**ADDENDUM NO. 3
SEPTEMBER 15, 2025**

**PROJECT: PECOS COUNTY WCID #1
 WELLS, PUMP STATION AND GROUND STORAGE TANK IMPROVEMENTS**

WELL No.12 AND WELL No.13
DETAILS

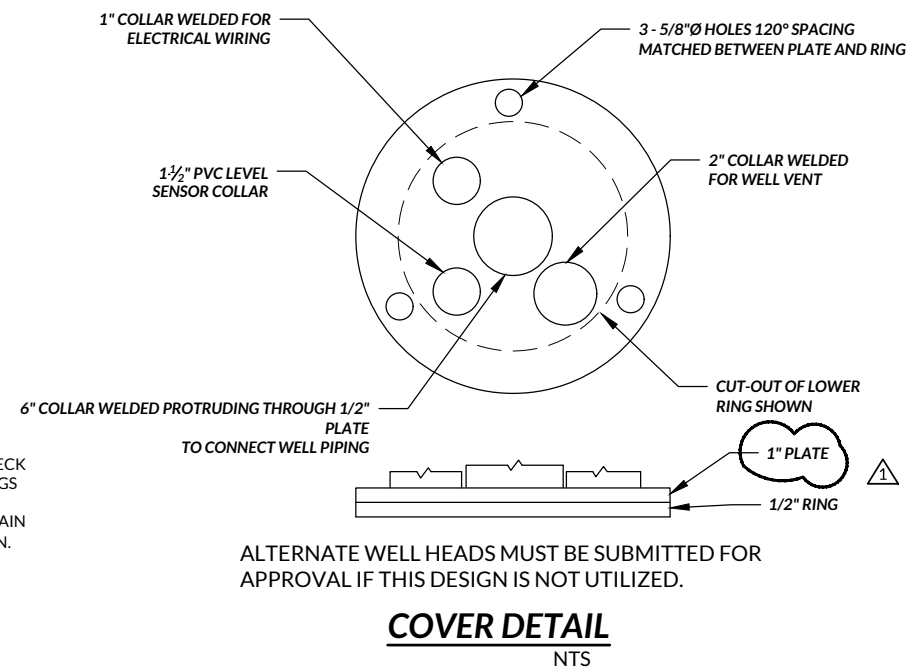
Sheet 06 has been revised to show a 1" plate thickness for Wells No. 12 & 13. The revised sheet is attached.
